PROJECT REVIEW COMMITTEE - CITY OF WILDWOOD
PRC Chairperson – Melanie Strickland

Agenda
Regular Meeting
February 11, 2025 10:00 AM
Commission Conference Room 124
100 N Main Street

**3. SP 2408-002 Dollar Tree at Twisted Oaks
Parcel D31A218**

**Reference: Dollar Tree at Twisted Oaks
SP 2408-002
Response to Comments 05**

PAVING, GRADING & DRAINAGE PLAN

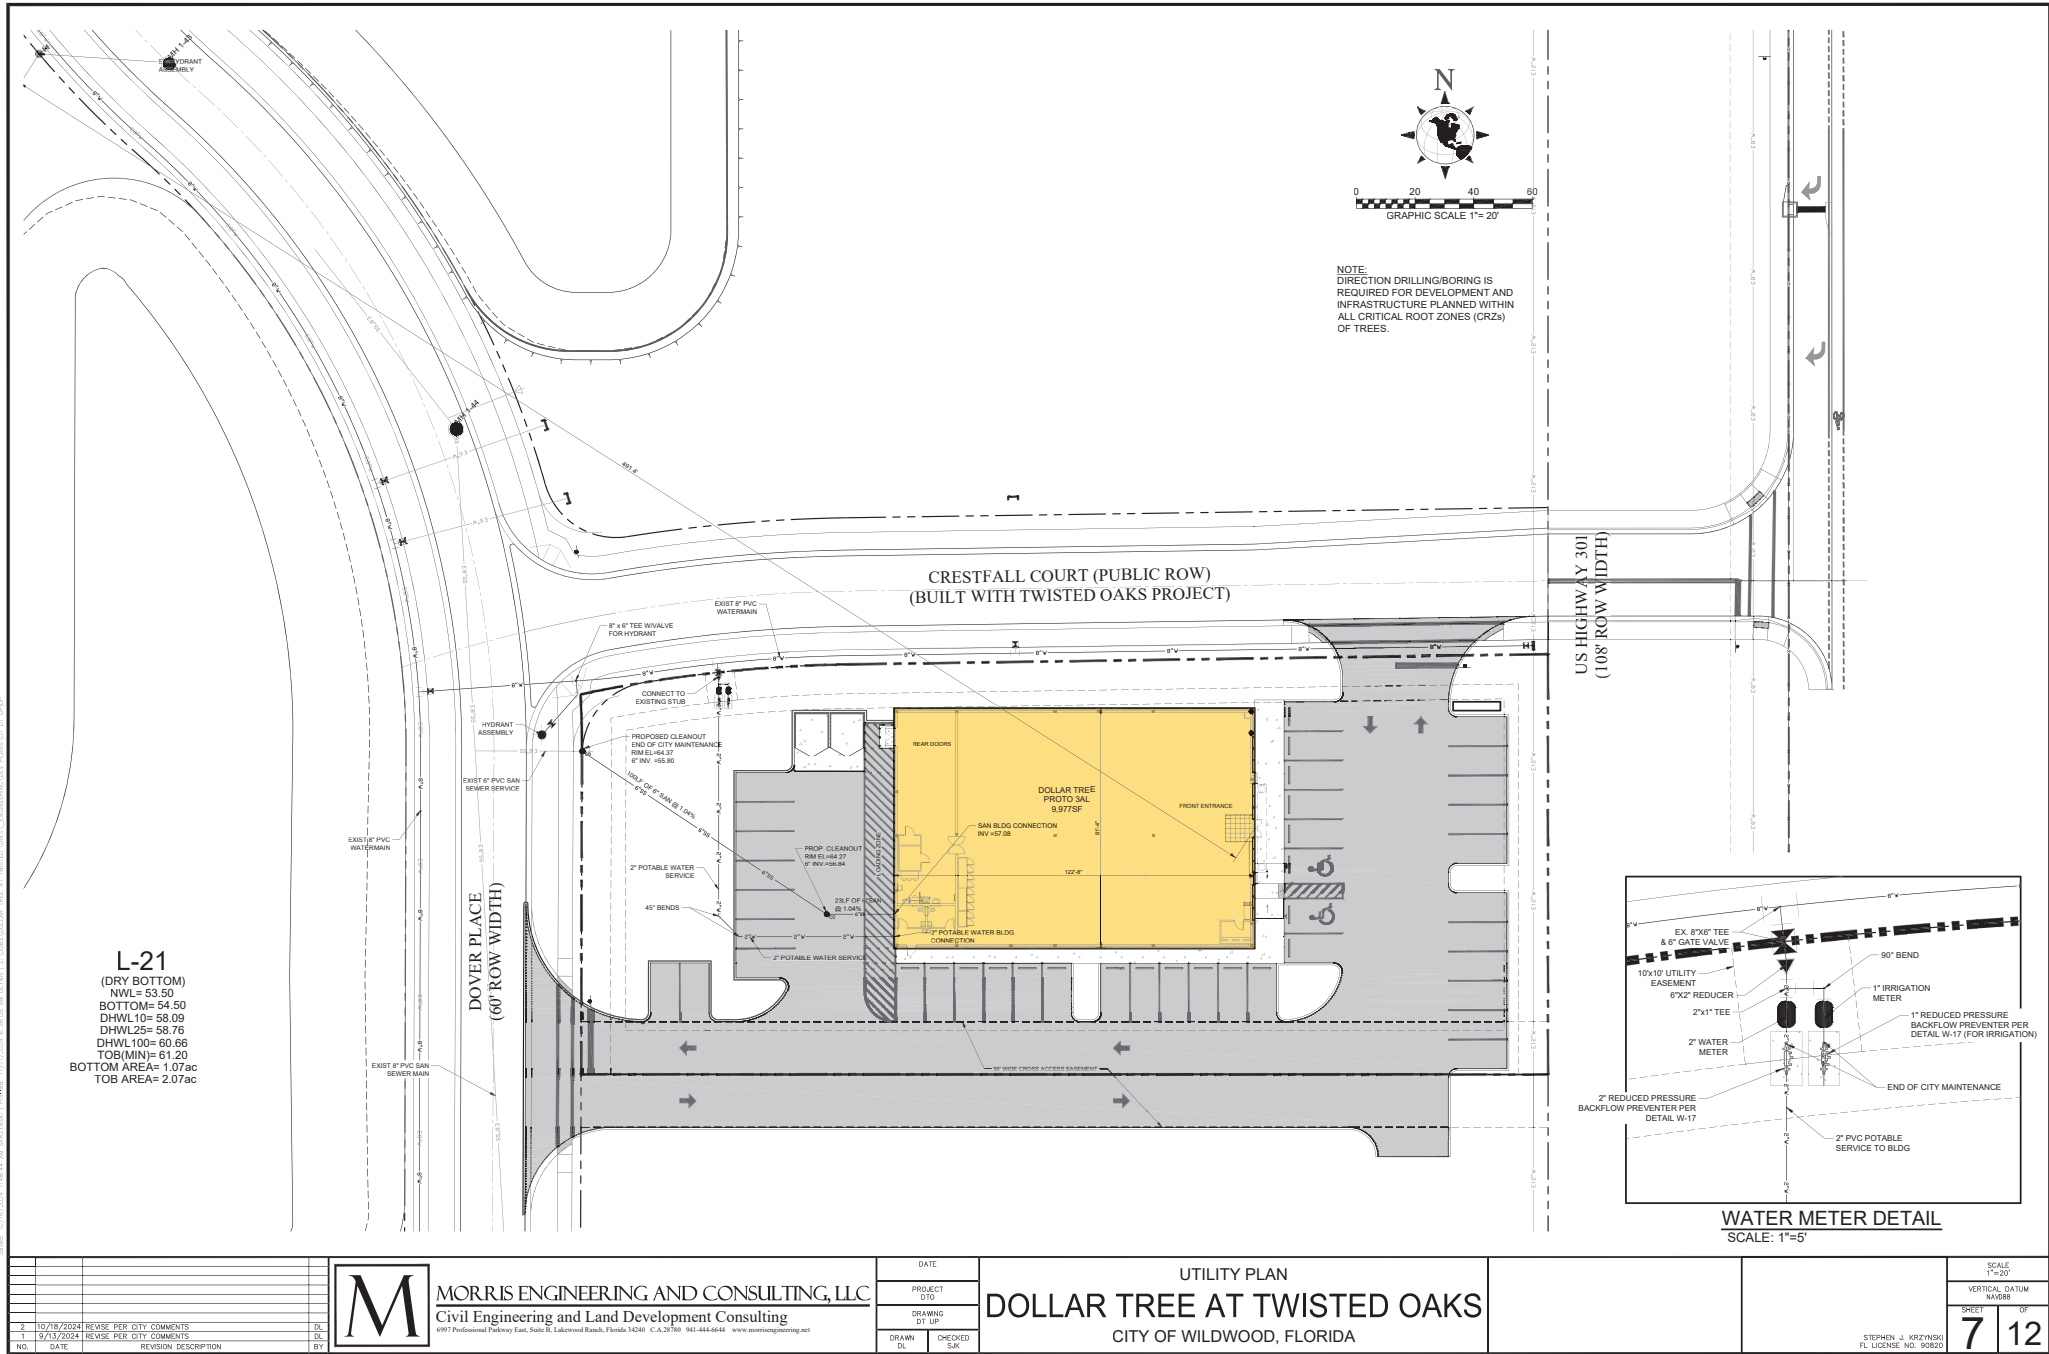
1. LD4.4(C)(9) – Please add end of city maintenance to utility plan on sheet 7.
 - A. Partially satisfied. Please add end of city maintenance note for water service as well.
 - a. **Response: End of City maintenance is shown in the water meter detail on the bottom right of the utility plan sheet 7.**
 - a. **Comment remains outstanding until #3 below is satisfied.**
 - a) **Response: See response to #3 below. As requested, end of city maintenance notes are shown on the plans.**
 - i. **Response acknowledged; comment remains outstanding**

Response: Acknowledged, please see response to #3.

Twisted Oaks Dollar Tree
Landscape Architecture
Morris Engineering & Consulting, LLC
Wildwood, Florida
OVERALL IRRIGATION PLAN

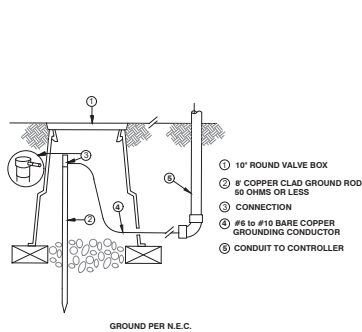
1. Sheet L500, Irrigation Plan states a minimum of 17 gpm @ 60 psi is required; the plan also provides for a $\frac{3}{4}$ " RPZ on the irrigation system. The backflow will have a minimum pressure loss of 8 psi from the city system. Please make sure your engineer reviews the system pressure for the irrigation design.

Response: Per correspondence with the irrigation designer, the pressure loss at the backflow preventer was incorporated into the overall design of the system and will have enough pressure to properly operate.
